Amendments to the Drawings:

Appl. No. 10/020,739

AMENDMENT Dated 1/08/2008

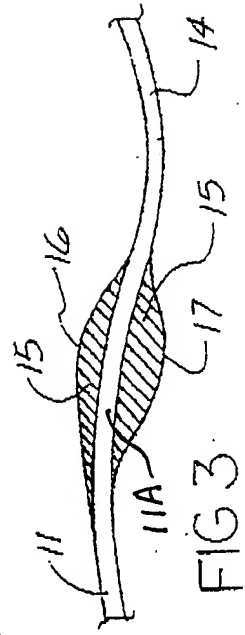
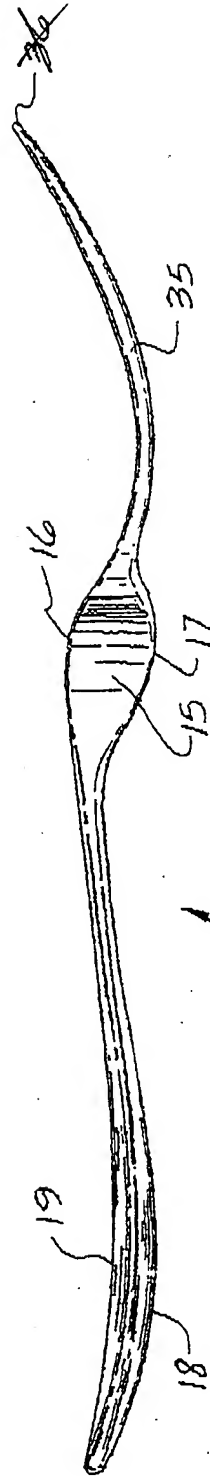
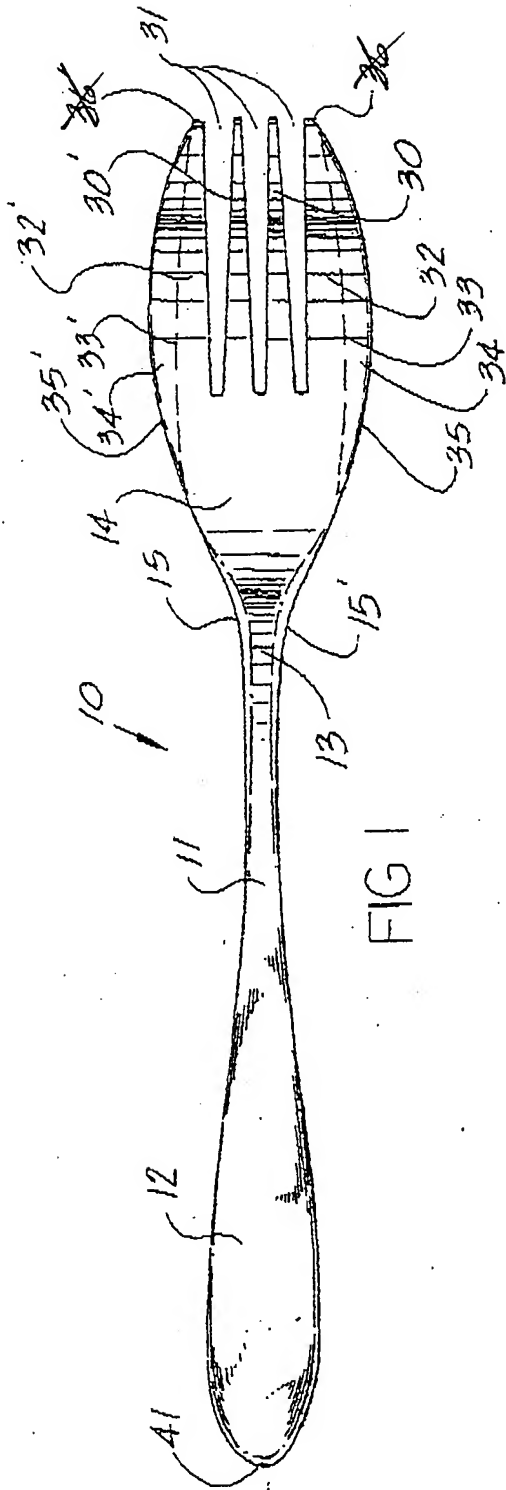
Corrected drawing sheets 1 and 3 are enclosed with this paper. On sheet 1, in Figs. 1 and 2, reference characters 36 and 36' have been deleted. Reference character 11A was added to Fig. 3.

1) The drawings include reference characters 36', 45 and 66' not mentioned in the specification.

2) The reference character 14 has been used to designate both the fork head and a typical fork handle.

3) Reference character 36 has been used to designate both a blade edge and a tine tip.

The drawings and specification have been corrected to address the above noted informalities.

FIG 8

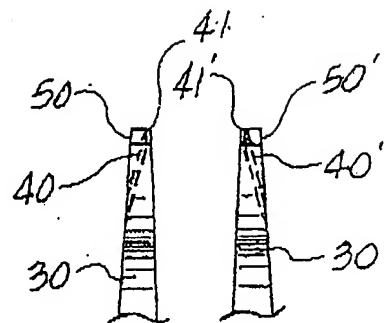
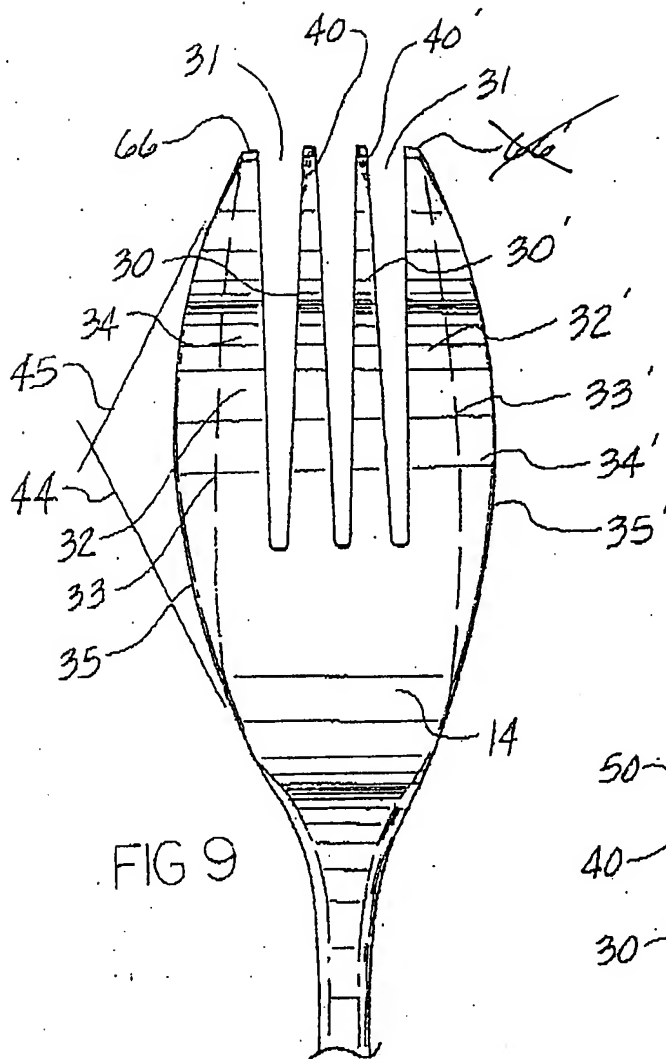
Paragraph 0038 of the specification is amended to reflect the addition of reference character 11A. On sheet 3 in Fig. 9, reference character 66' is deleted. Reference character 45 shown in Fig. 9 has been added to paragraph 0040 of the specification.
